PUBLIC UTILITIES COMMISSION

Advice Letter 6635-E-A/E-B/E-C

SUBJECT: Modifications to Electric Tariff Rule 21 to Incorporate IEEE 1547.1-2020 Test Procedures into Testing Regime for Phase 2 and 3 Requirements in Compliance with Resolutions E-5000 and E 5036

Subject: Supplemental - Modifications to Electric Tariff Rule 21 to Incorporate IEEE 1547.1-2020 Test Procedures into Testing Regime for Phase 2 and 3 Requirements in Compliance with Resolutions E-5000 and E-5036

Figure P-1: Voltage and Reactive Default Settings

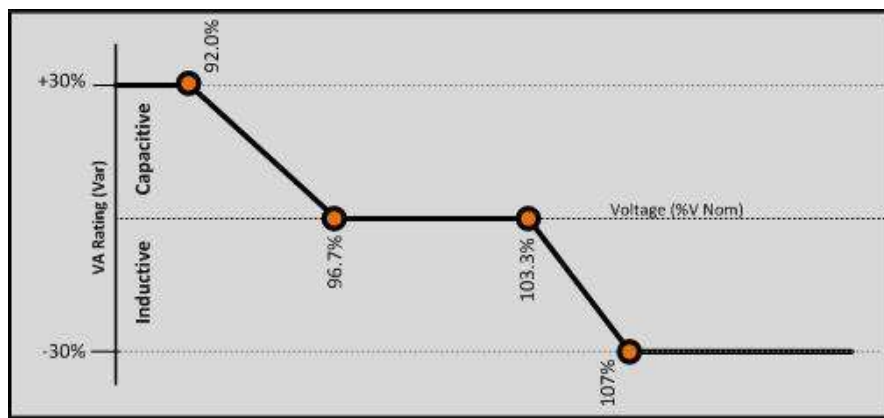
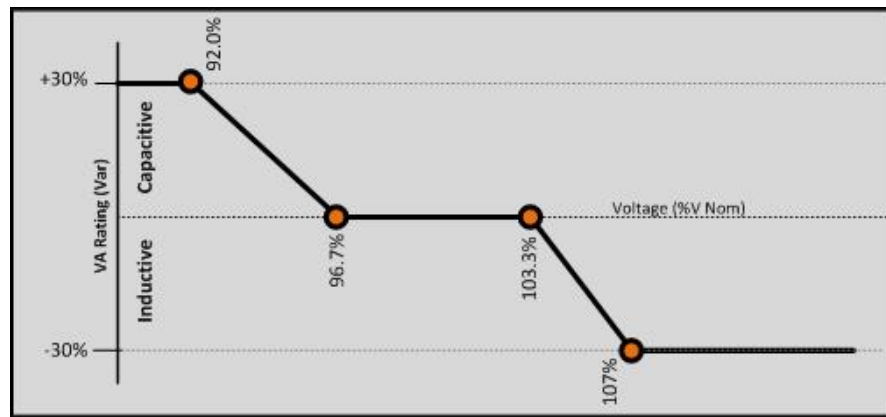
Table P-4 and Figure P-1 depict the default setting, which should be applied for all inverter size. Specific volt/var settings may be required for larger generating facilities (such as 100 kW or greater) or for specific areas with the Distribution System as determined by the Distribution Provider.

Default Open Loop Response Time for volt/var operation setting should be five (5) seconds.

Figure P-3: Volt-Watt Requirements

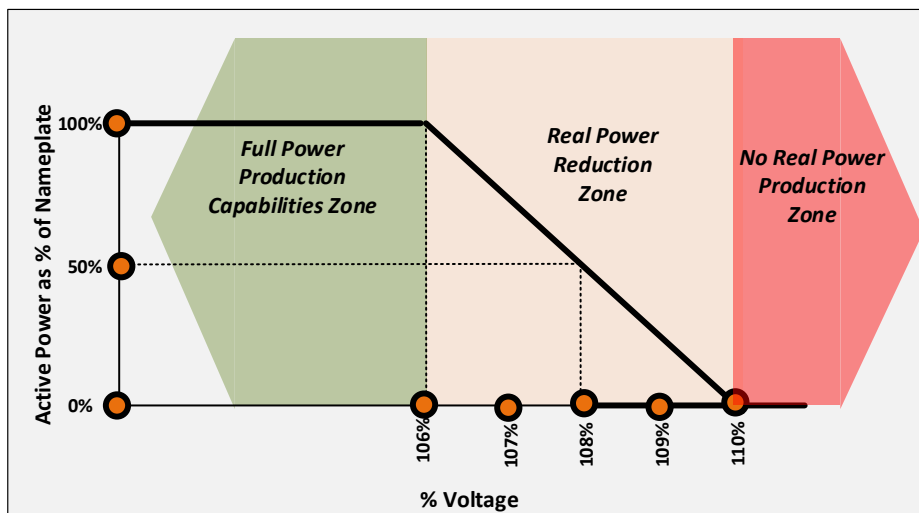
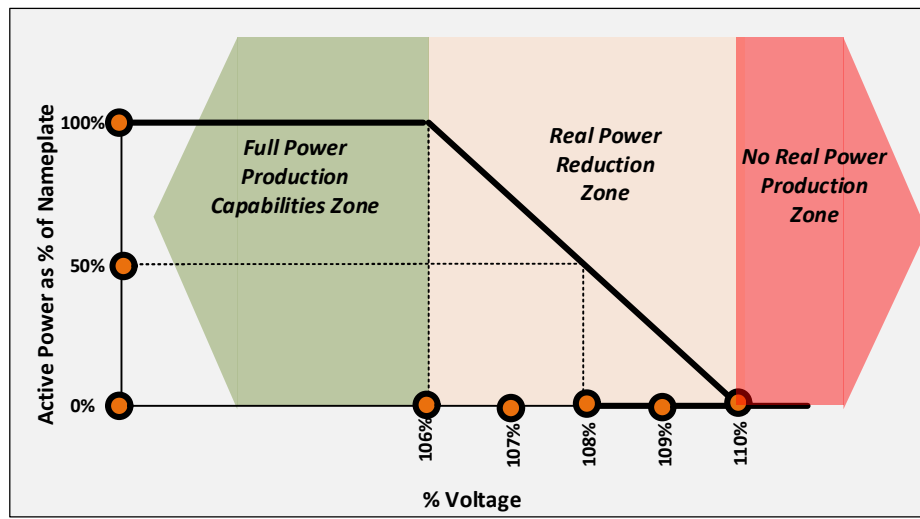
- When the measured voltage is greater than 110% of nominal voltage (Example: 132 volts on a 120 volts nominal), the export of active power to the grid at the PCC or the production of active power by the Smart Inverter shall be reduced to 0 watts.
- Open Loop response time shall be 5 seconds.

Figure P-5: Generating Facility Communications

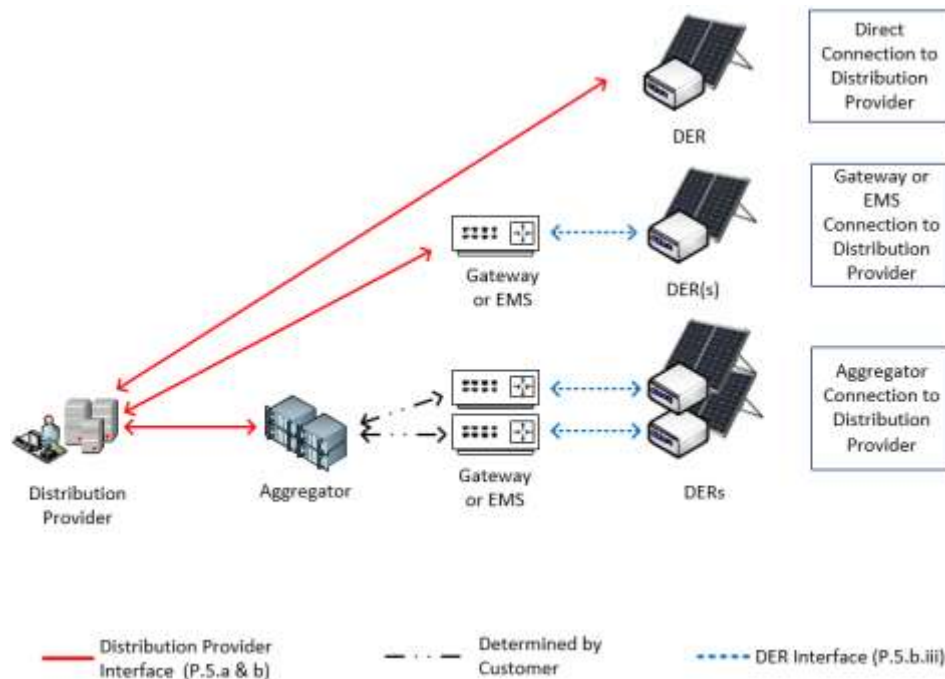
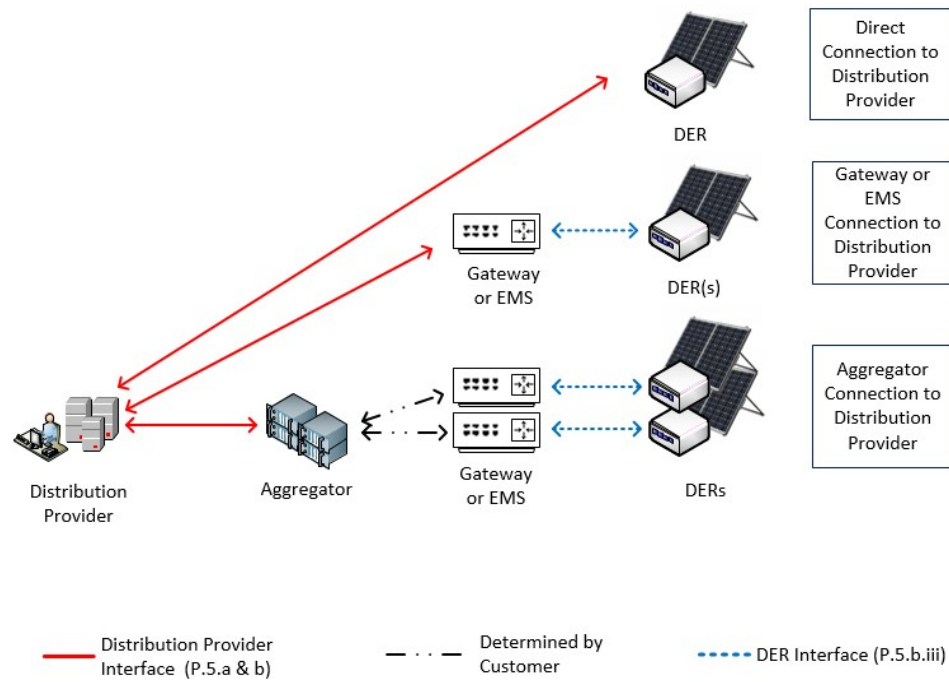
Should communications to the Distribution Provider be required, Generating Facilities utilizing inverter-based technologies must adhere to the following communication requirements for communications between the Distribution Provider and the Generating Facility. The diagram below shows the interface requirements as applicable for section P.5. The Distribution Provider Interface (solid red line) is described in Sections P.5.a and P.5.b. The local DER interface at the Generating Facility (dotted blue line) is described in Section P.5.b.iii. The top row shows a direct connection between the Distribution Provider and the DER. The middle row shows a connection between the Distribution Provider and a gateway (GW) or Energy Management System (EMS). The lower row shows a connection between the Distribution Provider and an aggregator.
